Re: FOUNTAIN PRICING

To: Chris Campbell (239) 418-0321	From: Emad Hanna
Fax: (239) 418-0321	Pages: 4 Including Cover Sheet
Phone: (239) 277-0009	Date: 10-26-06
Re: Fountain	cc:

ESTANCIA FOUNTAIN REPORT 6.15.06  
ZORRO RANCH NEW MEXICO

PROFILE OF FOUNTAIN  
BASED ON PHOTO GRAPH

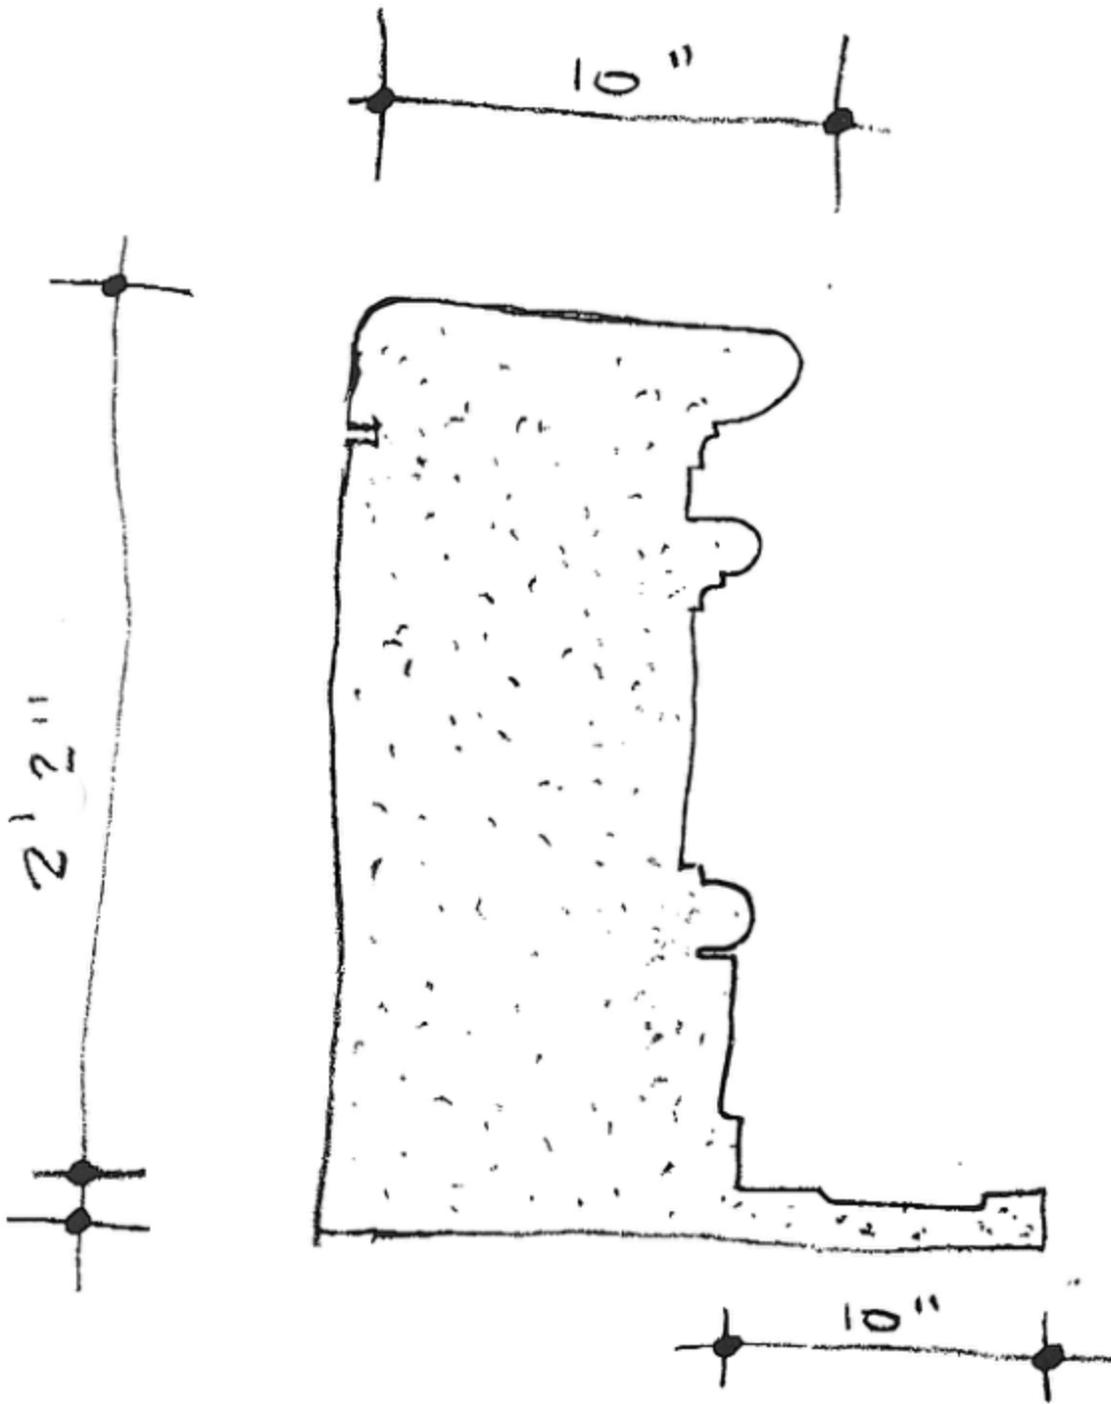
Here are some sketches done by our architect please review and get back to me. The sample that was sent to Brice we don't feel will hold up in the conditions at New Mexico and we would prefer the fountain to be made with granite. Please let me know if this can be done.

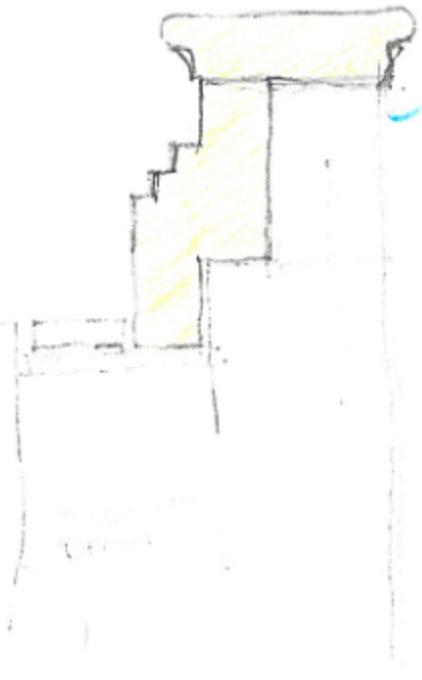
1. THE EXISTING TILES ON THE FOUNTAIN ARE FALLING OFF; AGAIN.
2. THE EASY FIX IS TO RESURFACE THE EXISTING FOUNTAIN WITH ANYTHING BUT TILE. SLABS OF STONE, PROBABLY GRANITE, COVERING THE FOUNTAIN IS ONE OPTION, DECORATIVE BRASS PLATES WITH HAMMERED METAL LINER IS ANOTHER.
3. THE HEIGHT OF THE EXISTING SQUARE FOUNTAIN COULD BE RAISED USING BLOCKS OF CARVED LIMESTONE, POSSIBLY FROM ANTIQUARIAN PROVIDERS, WHICH WAS A GREAT WEBSITE. THE BASIN LINING WOULD BE HAMMERED METAL.
4. THE EXISTING FOUNTAIN IS ONLY 11 FEET SQUARE AND WATER SPRAY OFTEN SOAKS THE LIVING AROUND THE FOUNTAIN.
5. ONE OPTION IS TO COMPLETELY REMOVE THE FOUNTAIN & TRENCH DRAIN AND START OVER WITH A CONSIDERABLY LARGER FOUNTAIN BASIN IN A DIFFERENT SHAPE. CURTILE DRAINAGE WILL STILL BE REQUIRED AT THE NEW FOUNTAIN PERIMETER.

6. THE EXISTING FOUNTAIN & TRENCH DRAIN ARE CONSTRUCTED OF REINFORCED CONCRETE WHICH CAN BE REMOVED BY HANDWORKING MEN WITH <sup>JACKHAMMERS &</sup> WHEEL BARROWS. A NEW CONCRETE FOUNTAIN BASIN & DRAIN WOULD BE FORMED & POURED, PIPING RECONNECTED AND PAVING REPAIRED. FOUNTAIN REPLACEMENT IS A PRODUCTION BUT CAN BE DONE, PROVIDED THERE IS A DESIGN FOR A NEW FOUNTAIN WITH ITS SIZE & SHAPE DETERMINED.
7. WHAT IS THE FOUNTAIN TO LOOK LIKE? IT'S A TOUGH QUESTION. ENCLOSURES ARE PICTURES OF VARIOUS FOUNTAINS SOME NICE, SOME AWFUL. YOU WON'T BELIEVE THE FOUNTAIN DAWDLES TRUMP POT IN FRONT OF ARBE GOSSMANN'S HOUSE - HORSES AND EVERYTHING!

Recommendation: WATER STOP  
 Waterproofing
